Detailed Site Plan DSP-18055

Ardwick Ardmore Consolidated Self Storage

REQUEST	STAFF RECOMMENDATION
Construction of a 114,000-square-foot consolidated storage facility.	APPROVAL with conditions

STAFF REPORT

NORTH & SOUTH ELEVATIONS

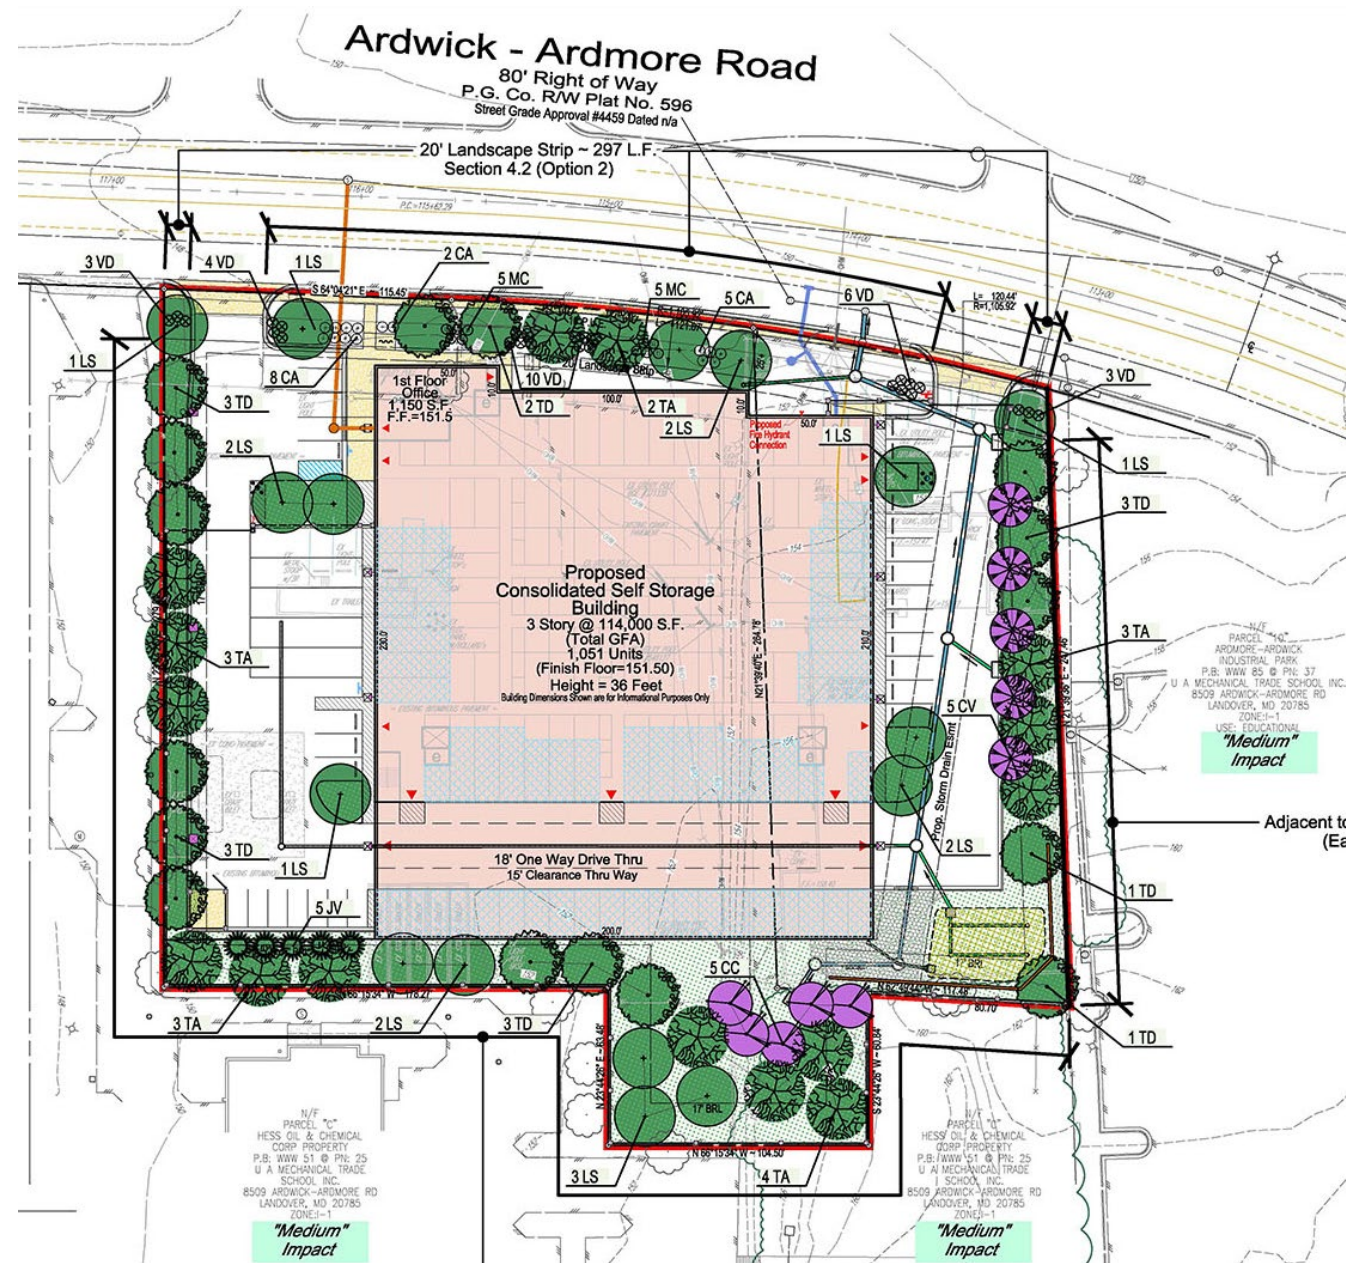
- d. Provide building width dimensions on the architectural elevations that are consistent with those on the site plan to clearly demonstrate conformance to Section 27-613 of the Zoning Ordinance.

- g. Label the height of the clearance provided in the drive-through opening on the architectural elevations.
 - h. Provide screening or landscaping to adequately screen the electrical transformer facing Ardwick-Ardmore Road.

5 Light Pole Foundation Detail
 Scale: 1/2" = 1'-0"

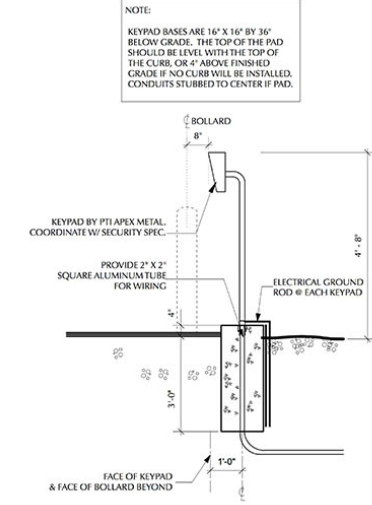
- 1. Prior to certification of the detailed site plan, the following revisions shall be made to the plans:
 - a. Provide details of the light pole to be used on-site.

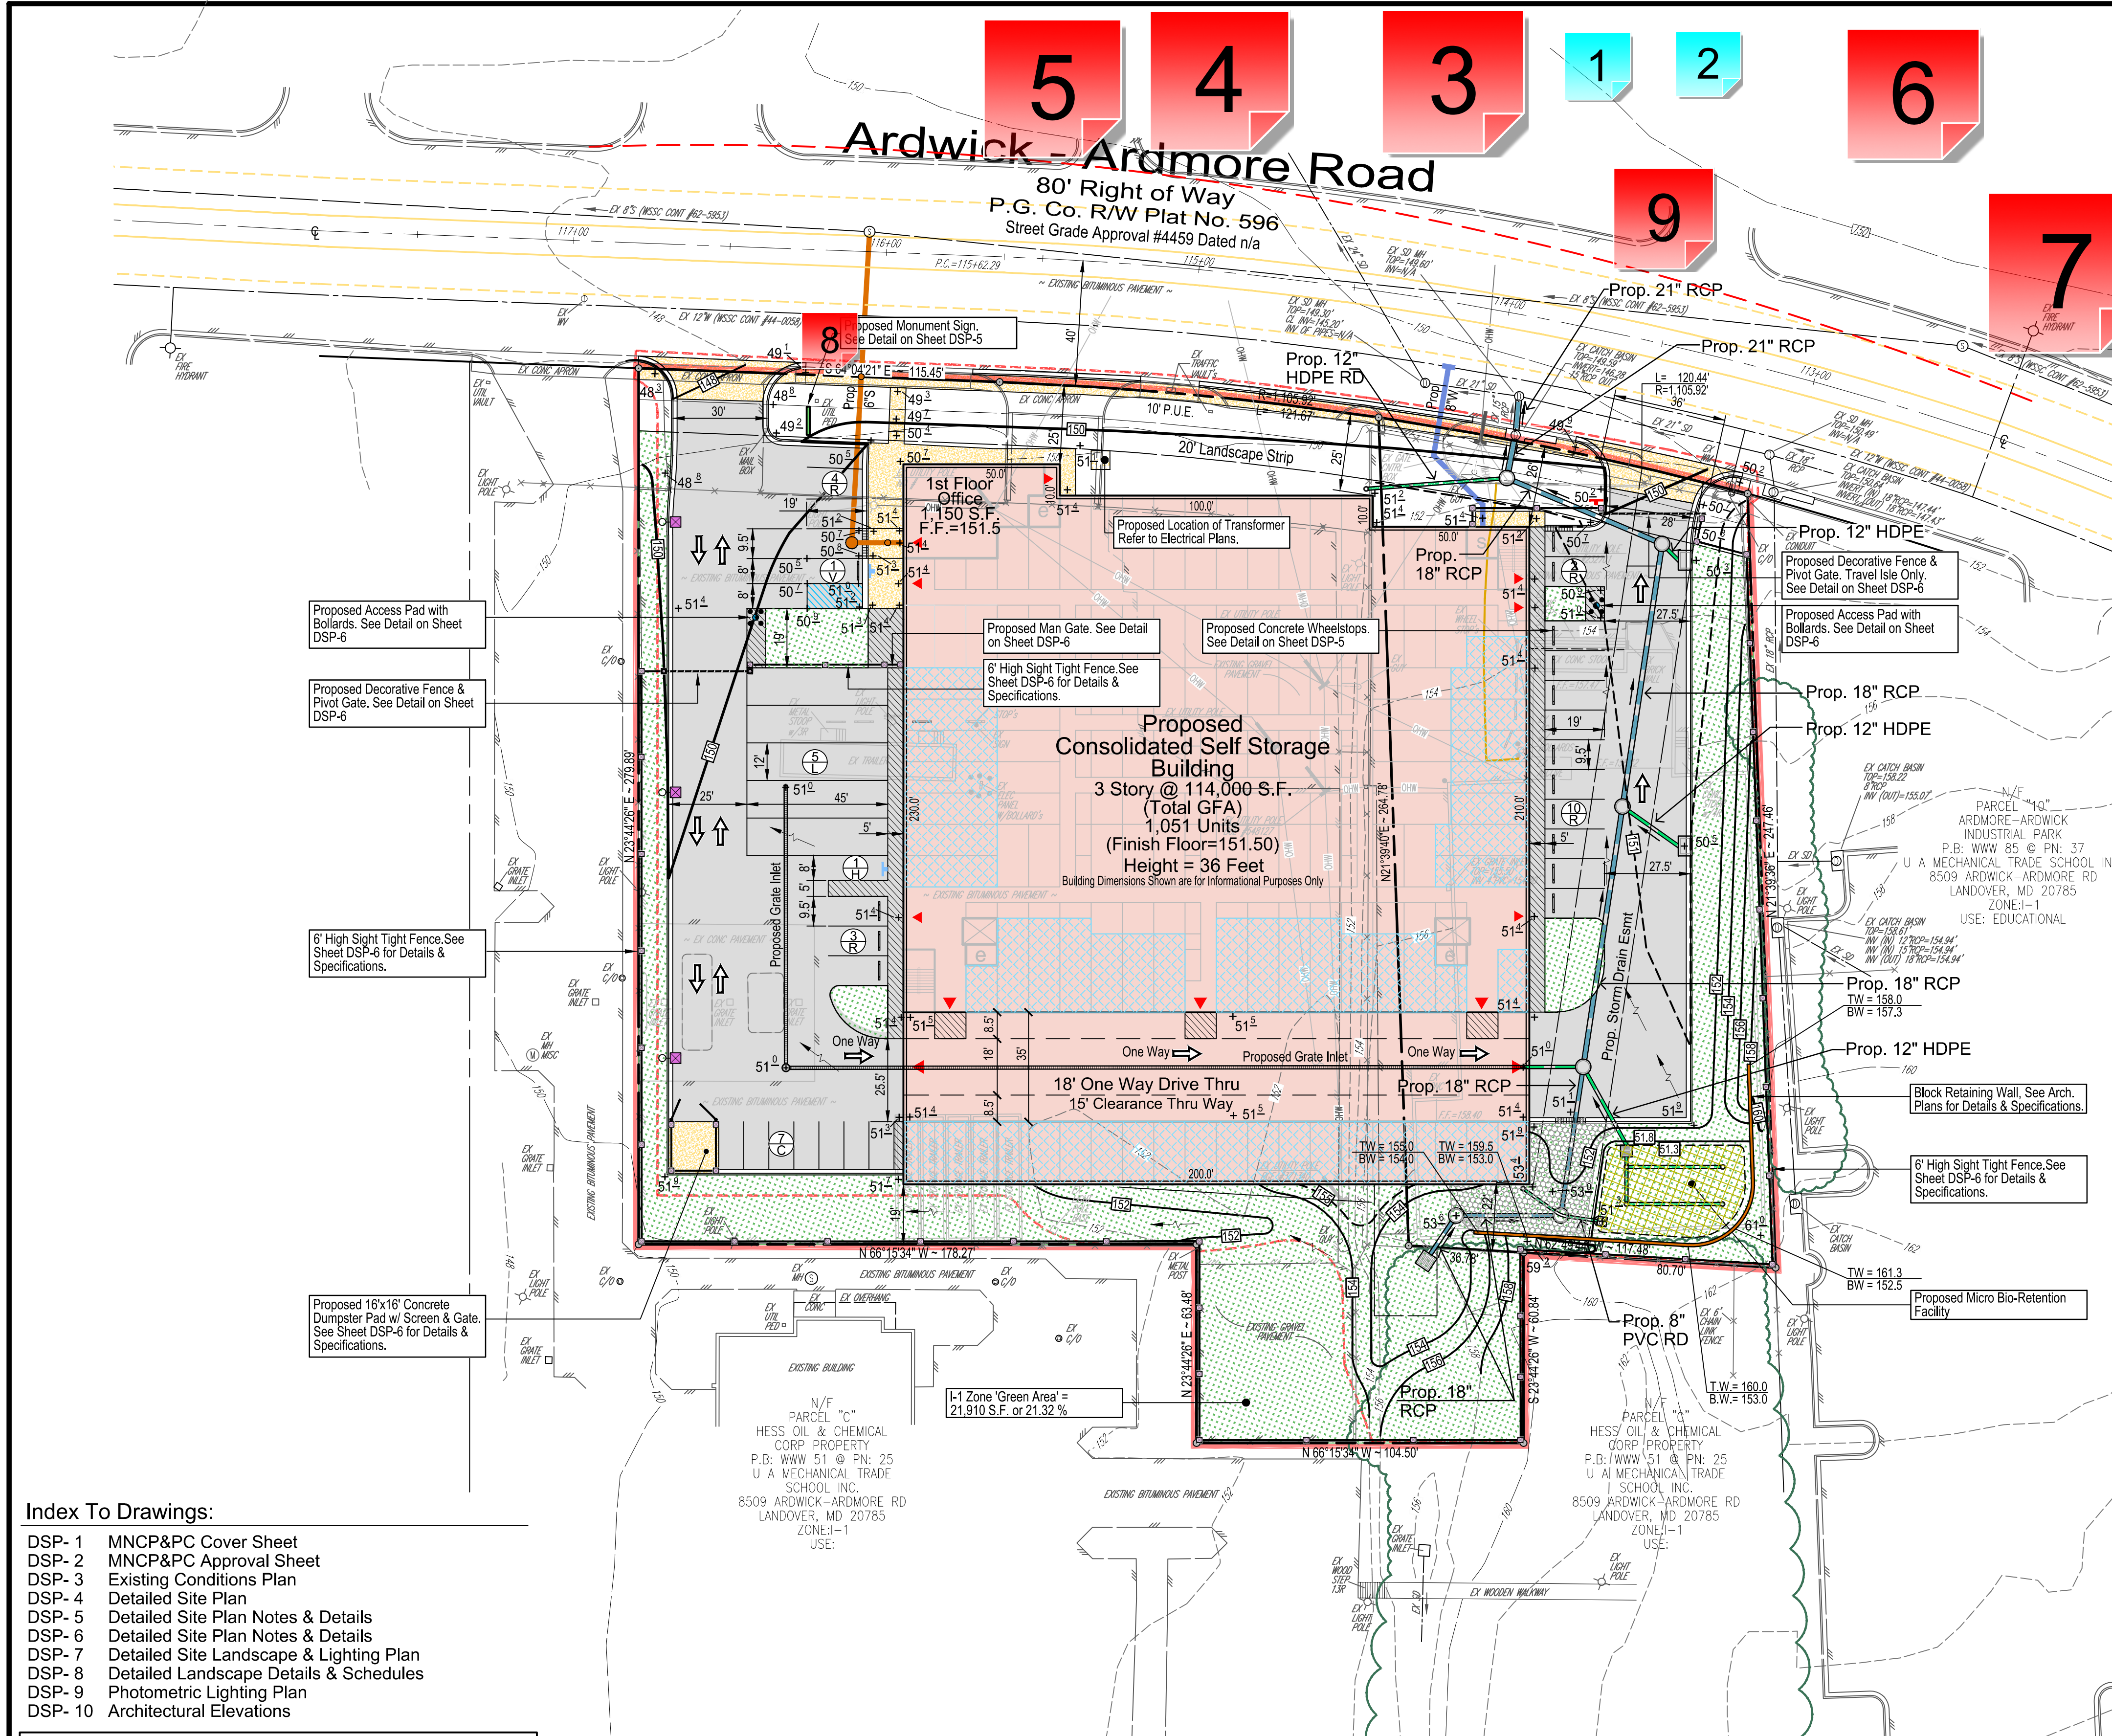
1. Show monument sign setback on DSP, Sheet DSP-4, to demonstrate conformance to Zoning Ordinance.
2. Revise General Note 7, Parking, as shown below:

4. It would be helpful to further demonstrate conformance to Sec. 27-613 for signs attached to buildings & canopies, if the applicant provided building width dimensions on the architectural elevations, Sheet DSP-10, North and West Elevations.
